RE: **Palen Solar Power Project, Docket No. 09-AFC-7**

Responses to CEC Information Requests
Reconfigured Alternatives 2 and 3
Biological Resources
09-AFC-7

PALEN SOLAR POWER PROJECT (09-AFC-7) CEC STAFF DATA REQUESTS DATED JULY 9, 2010
Technical Area: Biological Resources (AFC Section 5.3) Response Date: July 19, 2010

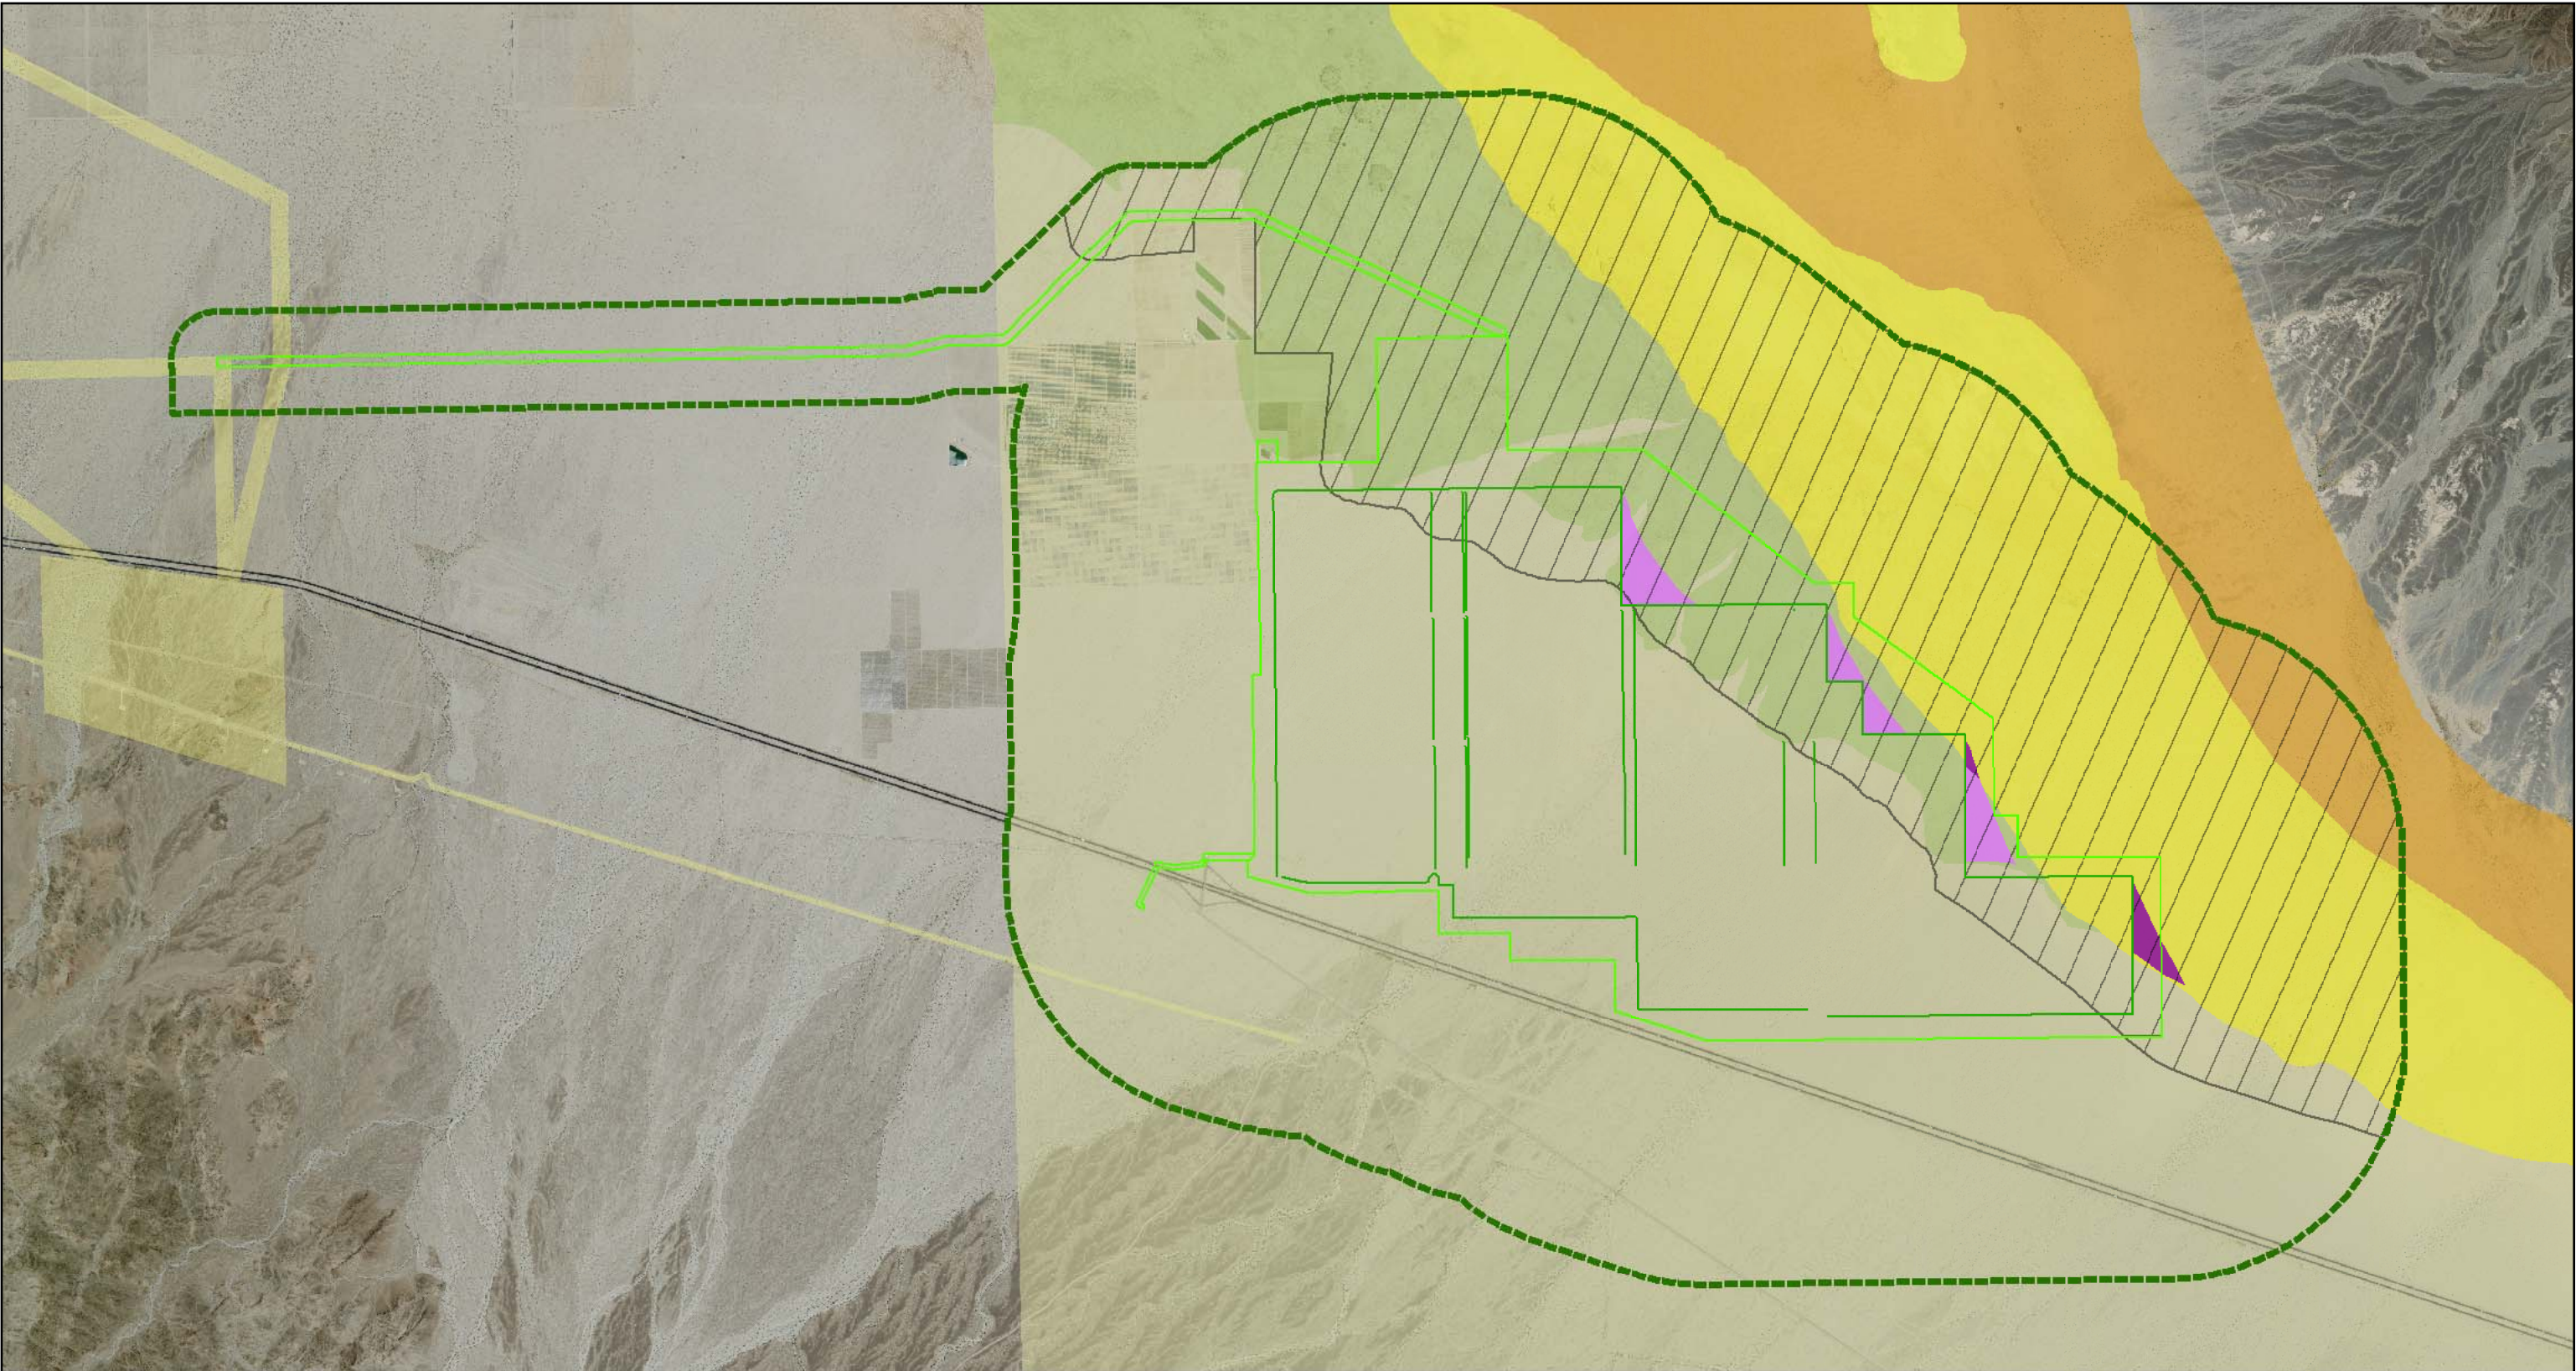
1. An analysis of impacts to the sand transport corridor and Mojave fringe-toed lizard habitat, including direct and indirect impact acreages (by Zone and also overall MFTL habitat). If sand management activities such as clearing accumulated sand from the base of the wind fencing are proposed (please provide as much detail as possible on those proposed activities, including information about the anticipated frequency and volume of sand removal, the kind of equipment that would be used to excavate and transport sand, measures that would be taken to protect surrounding habitat and wildlife, and a figure depicting the location proposed for depositing the sand).

The Applicant has endeavored to design Reconfigured Alternatives 2 and 3 in such a manner that would further reduce disturbance within Zone II of the identified sand transport corridor. As described in the previous reports by Dr. Miles Kenney, the vast majority of all sand transport in this corridor is within Zone I, likely greater than 80 percent. Zone II accounts for the majority of the up to 20 percent remainder. Therefore, the Applicant does not believe either of the Reconfigured Alternatives impact the sand transport corridor. Portions of Zone II and Zone III are however, MFTL habitat. Dr. Kenney has updated his analysis to address the two alternatives; the updated analysis is attached to this submittal;

Attachment BIO-A contains all Biology figures. Figure BIO-1 depicts the Reconfigured Alternative 2 Disturbance Area overlain on sand transport zones and MFTL habitat. Figure BIO-2 depicts the Reconfigured Alternative 3 Disturbance Area overlain on sand transport zones and MFTL habitat. Table 1 presents direct and indirect impacts to MFTL habitat. There are no direct impacts to Zone I for either Reconfigured Alternative 2 or 3. We have calculated theoretical indirect impacts resulting in "sand shadows" that could potentially occur as a result of the blockage of sand by the wind fence around the northern boundary of the site. These theoretical sand shadows are shown in the Figure BIO-1 and BIO-2 as areas of purple shadow. Due to the very low quantity of sand movement and the wind direction, the Applicant does not agree that these theoretical sand shadows would result in significant impacts to MFTL habitat. However, the disagreement with Staff is moot because all but an extremely minimal amount of sand shadow falls outside the Disturbance Area boundaries (approximately 4.5 acres for Reconfigured Alternative 2 and 2.3 acres for Reconfigured Alternative 3). areas located within the Disturbance Area boundaries are already counted as permanent direct impacts. Direct impacts to MFTL will be mitigated by purchasing habitat.

Palen Solar Power Project
Figure BIO-4

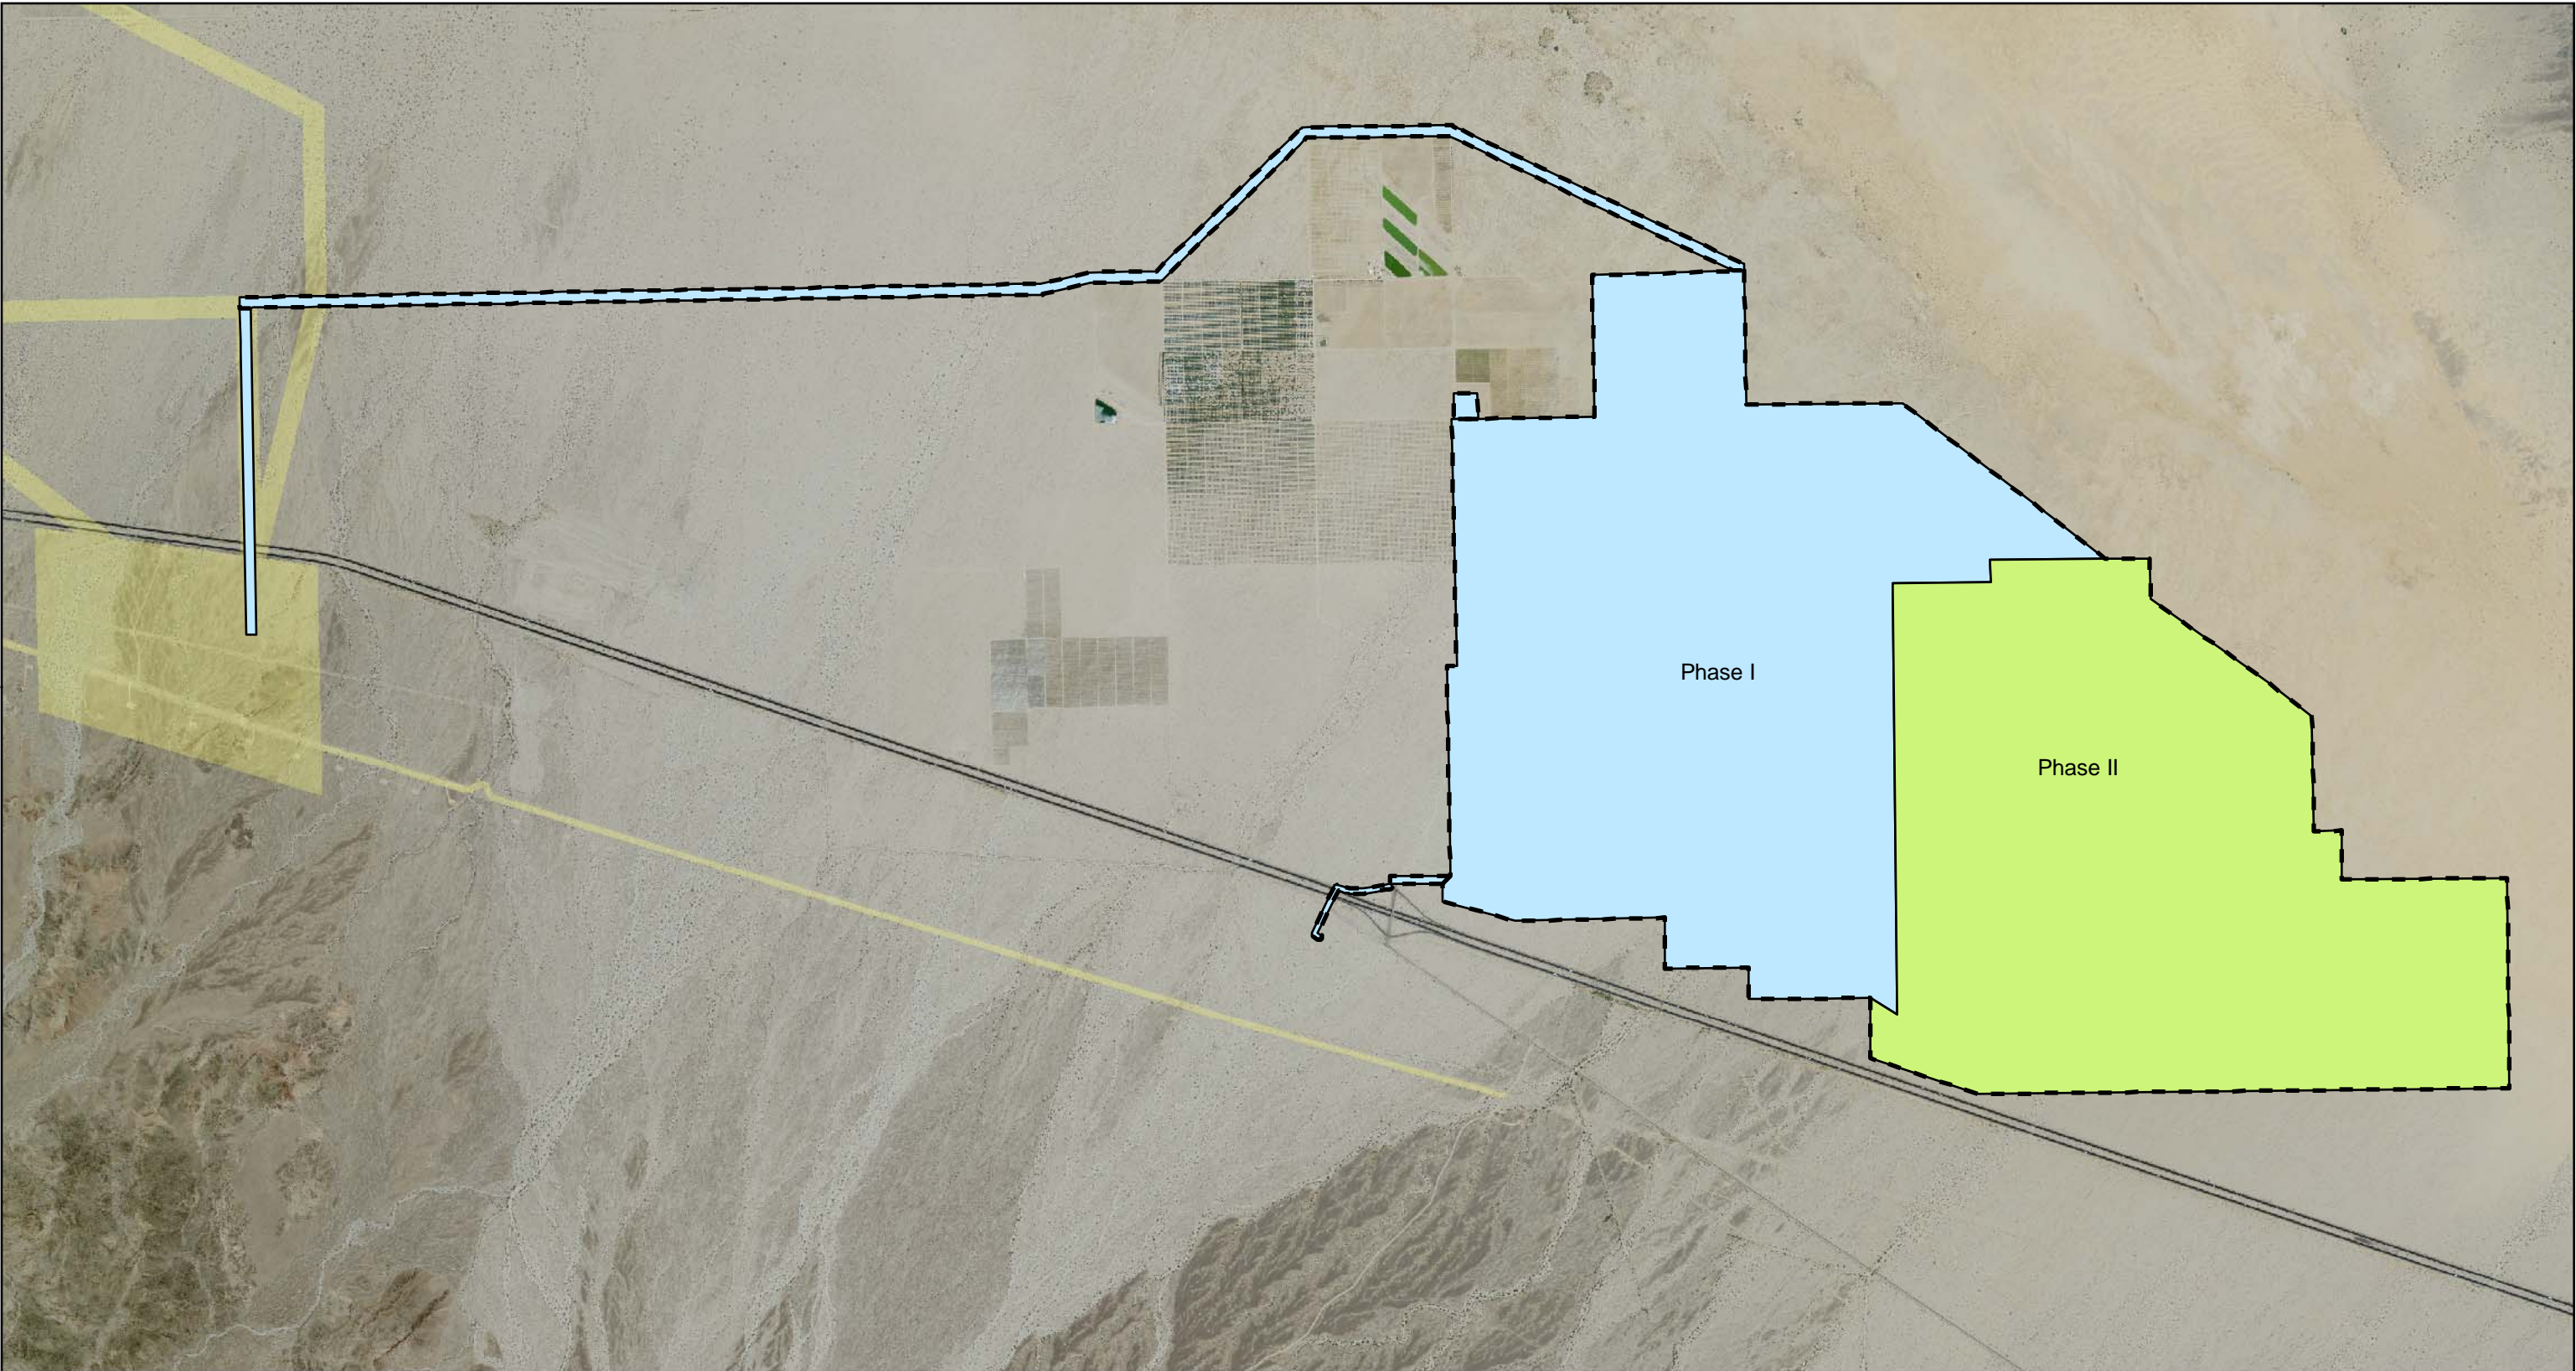
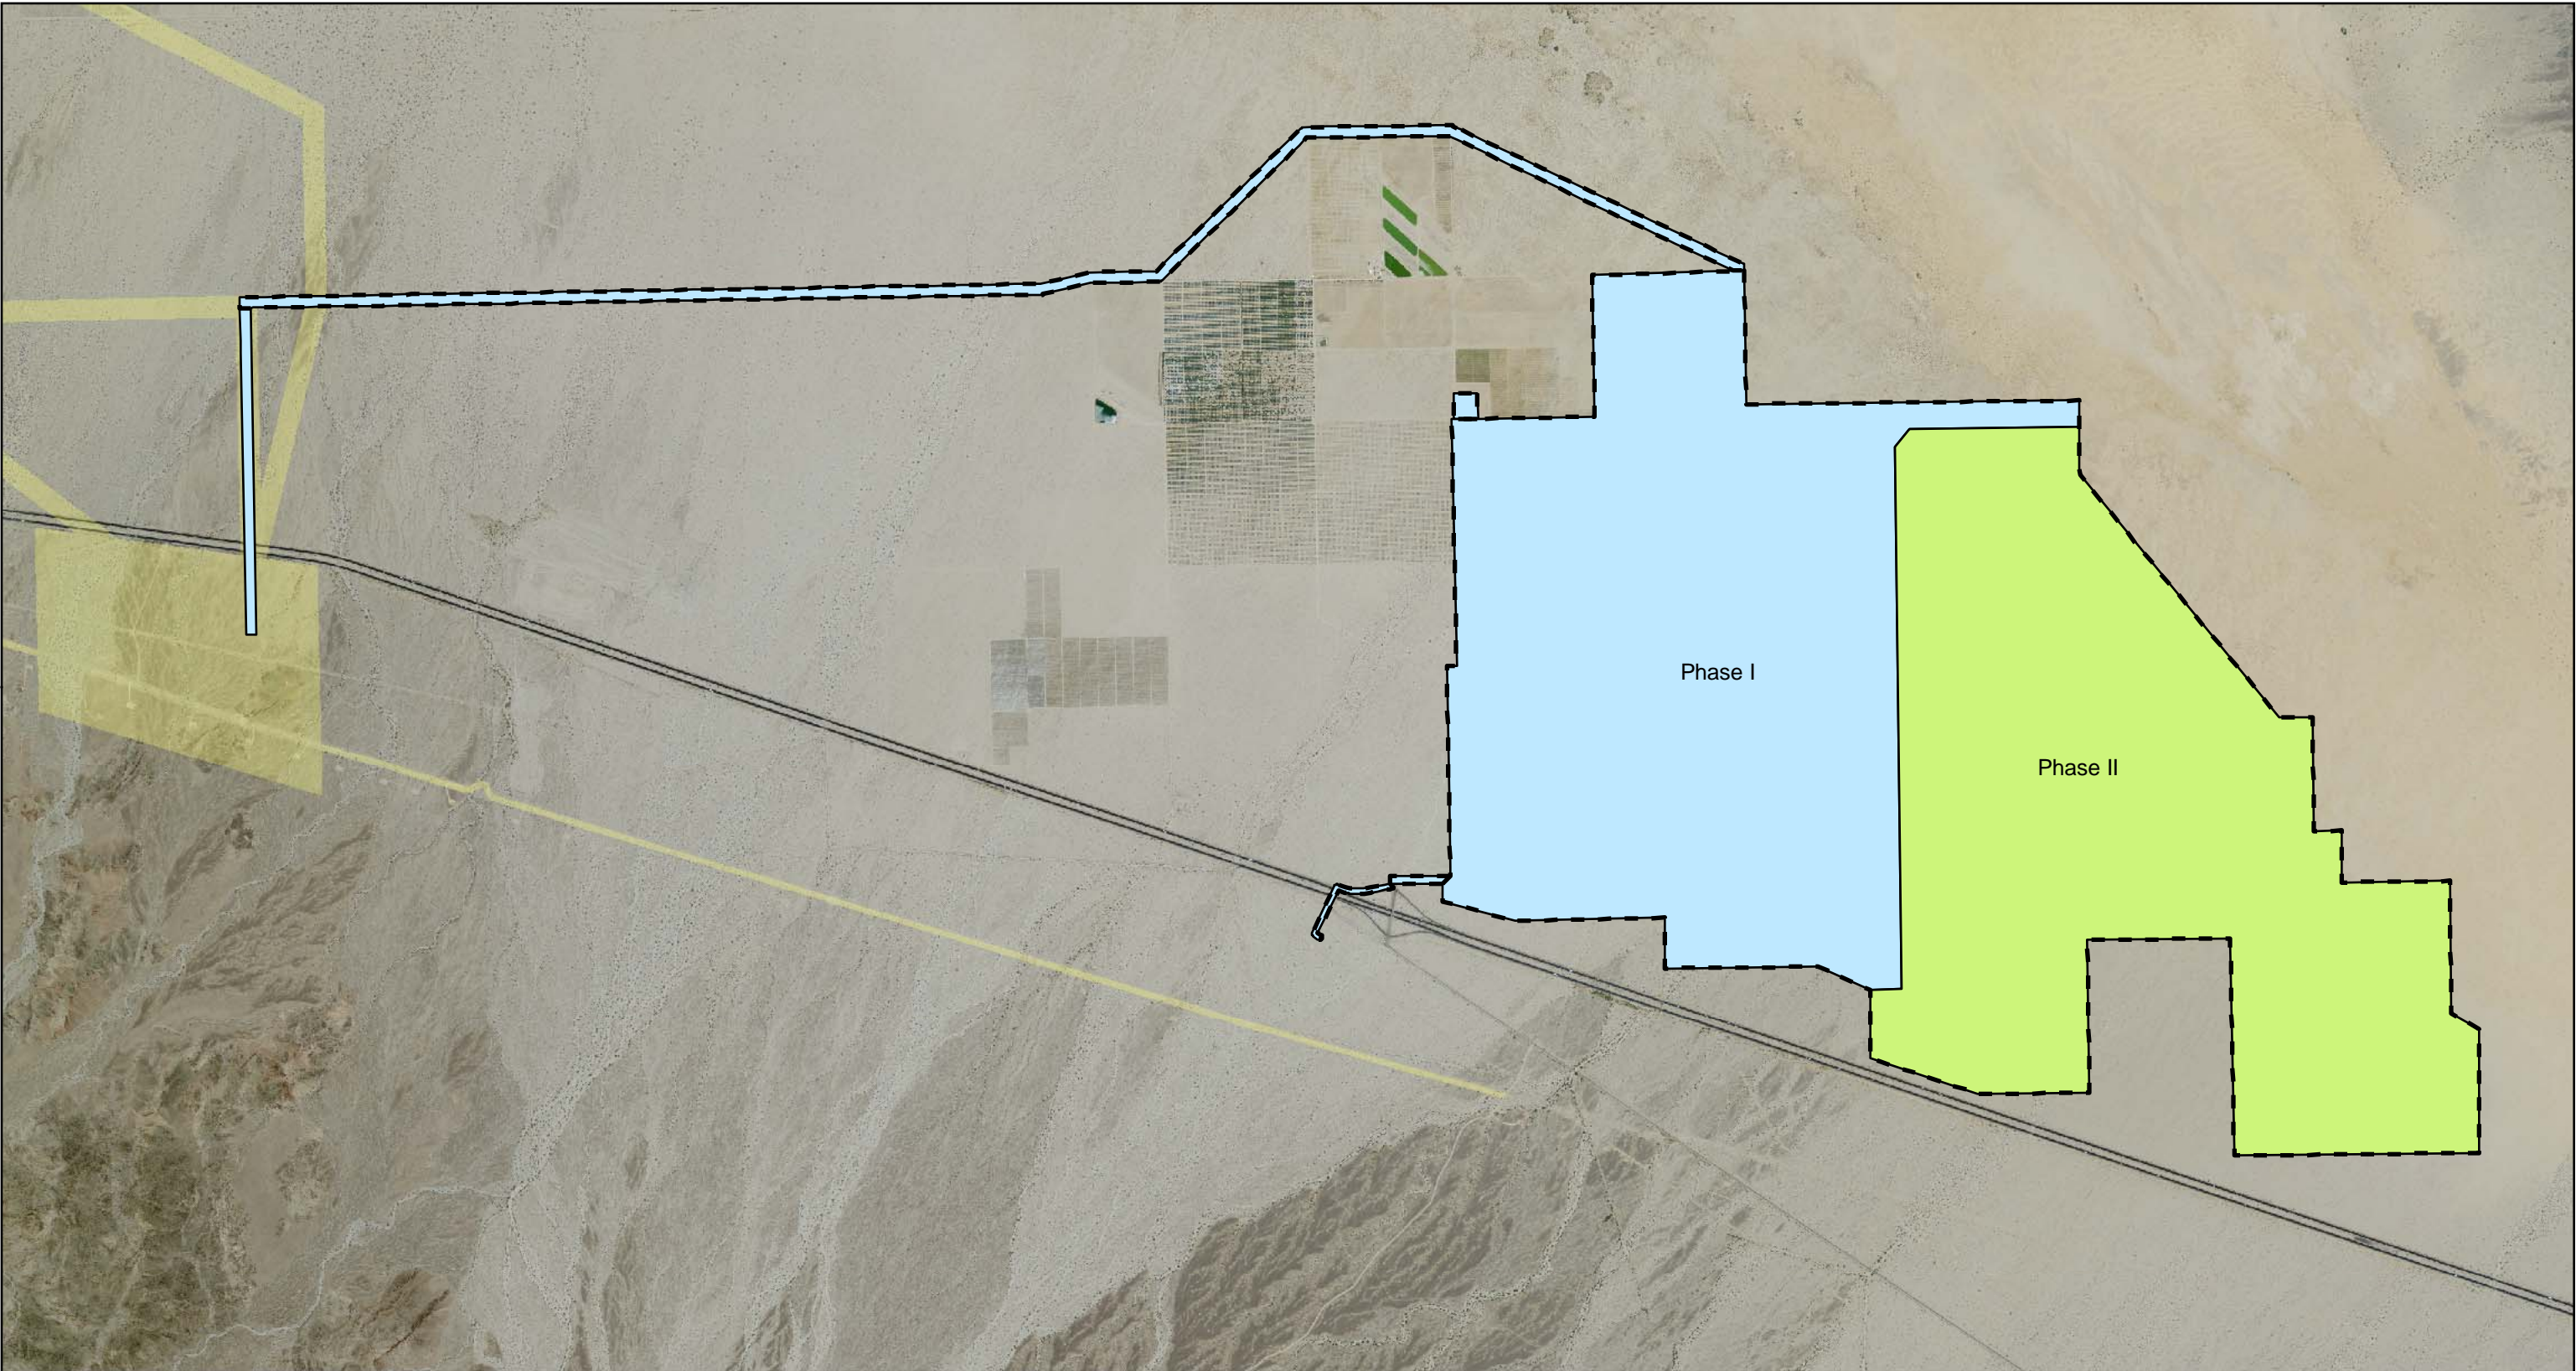
2. Number of acres within DT Critical Habitat

Figures 13 and 14 from the PSPP Biological Resources Data Package submitted to the CEC on July 2, 2010 depict the DT suitable habitat and DT Critical Habitat within the Reconfigured Alternatives 2 and 3 Disturbance Areas. As reported in Table 7 of that Data Package, the Reconfigured Alternative 2 Disturbance Area contains approximately 11.47 acres of moderate quality DT Critical Habitat and 216.92 acres of low quality DT Critical Habitat. The Reconfigured Alternative 3 Disturbance Area contains approximately 11.47 acres of moderate quality DT Critical Habitat and 216.92 acres of low quality DT Critical Habitat.
